# Determination 2023/039

## Compliance of handrails to an external stair with Clause D1 *Access routes*

**26 Lilburn Crescent, Massey, Auckland**

**Figure 2: The stair**

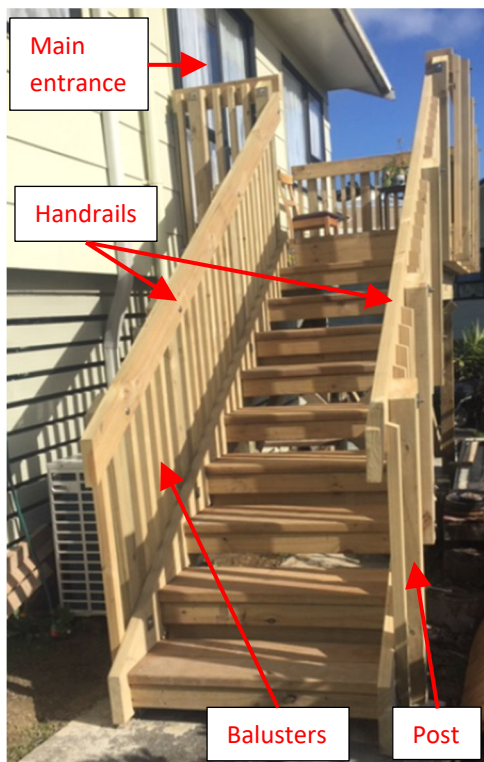
- 2.5. On 9 August 2023, the authority carried out a final inspection of the building work associated with the building consent. The inspection failed for several reasons<sup>8</sup>; in relation to the stair handrails the inspection record states, “Handrail to be made graspable, does not comply with D1/AS1, [relevant width<sup>9</sup>] exceeds 80mm”.

- The handrail must have a maximum graspable width of 80mm, where your hand is unimpeded for the entire length of the handrail,...
- 2.8. On or about 7 September 2023, the authority advised the builder (following receipt of the application for determination, which included further photographs) that it had initially considered the balusters were too close to the top of the handrail,

It states that the handrail must be graspable and that the measured top and clear sides of your 140mmx45mm [handrail] exceeds the maximum [relevant width of] 80mm specified in D1/AS1 fig26.

4.17. Based on the photographs and measurements provided by the builder, I am of the view that the handrails have been installed in a way that avoids of the likelihood of personal injury. The difference between the top surface of the handrail and the top of the posts and balusters is between 65mm to 80mm (refer to Figure 3). It is therefore possible to slide a hand up or down the length of the handrail without contacting an obstruction. I also note the authority accepts a hand “can pass...freely [along] both sides” (refer to paragraph **Error! Reference source not found.**).

- 4.25. In my view, the profile of the owner’s handrails meets the description of the measurement of “relevant width” in Figure 26(a) (ie “measured around the upper surface perimeter of the handrail section between the vertical tangents on each side”). The vertical tangents are the sides of the handrail, and the distance between them is 45mm. An adult’s hand will fit easily over this and down the side to provide a firm grasp. Figure 26(a) also states “Variations in shape are acceptable provided the effective grip is not reduced”. I consider the “effective grip” of the handrails is not reduced by their profile in this case, and they will provide a graspable support for anyone using the stair.

- 5.1. In accordance with section 188 of the Building Act 2004, I determine the two handrails, constructed as part of an external stair that serve as an access route to the owner's dwelling, comply with clause D1.3.3(j) of the Building Code.

**Figure 3: Outside view of balustrade**

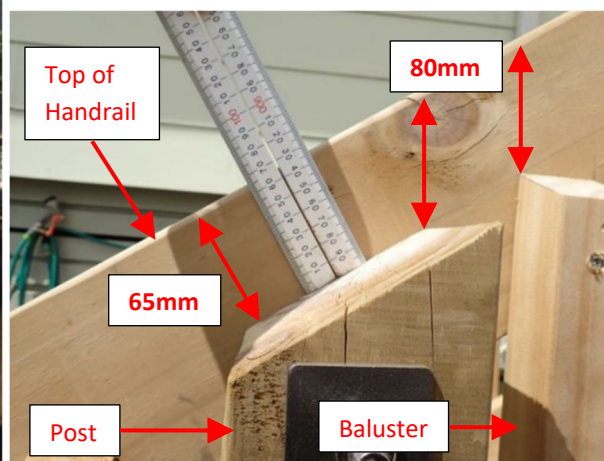
- 3.1.2. “The handrail has been installed in the upright position allowing the top of the rail to be graspable. The top of the rail is positioned to have a minimum of 30mm clear from any obstruction throughout, ie, [to the] top of [the] barrier post/s.”

4.13. The relevant paragraphs of D1/AS1 relating to handrails are in part 6.0, in particular, 6.0.7 and 6.0.8, and Figure 26(a) (copy provided below):<sup>15</sup>

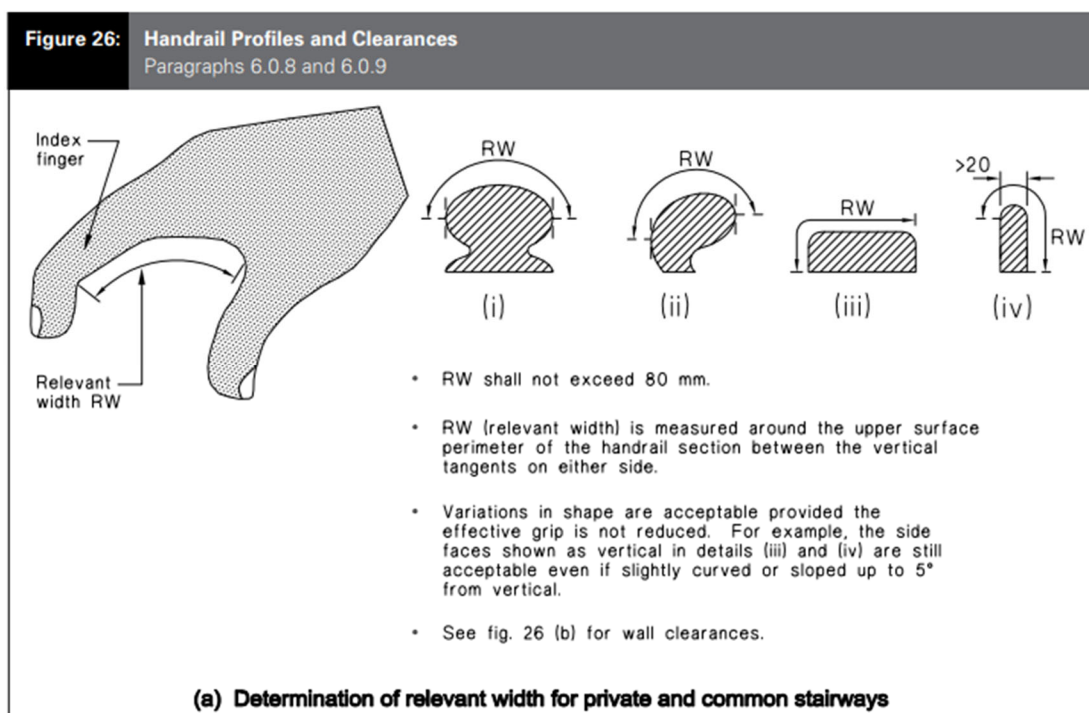
4.20. However, in the authority’s view, the relevant width of the handrails (also denoted as “RW” in Figure 26(a)) is greater than 80mm. The builder does not accept this, stating that the profile of the as-built handrail complies with the requirements in paragraph 6.0.8, and while its profile may not be exactly replicated in Figure 26(a), these are only examples and other options are allowable.

- 4.23. The parties hold differing views as to how the example profiles in Figure 26 should be interpreted. The profile most similar to the owner’s handrails is the one shown in example (iii). The authority in its correspondence to the builder has stated the handrail must have a “maximum graspable width of 80mm”, however, this is not what the example profiles show in Figure 26, or what paragraph 6.0.8(d) specifies.

- 4.24. Example (iii) in Figure 26(a) shows that the top surface of the handrail, plus a portion of one side constitutes the relevant width, and this must fit within the portion of a person’s grasp as shown in the figure. The top of the handrails in this case is only 45mm wide.

- 4.26. Taken together, I am of the view that the as-built handrails in this case meet the requirements of D1/AS1, therefore, compliance with clause D1.3.3(j) has been achieved.
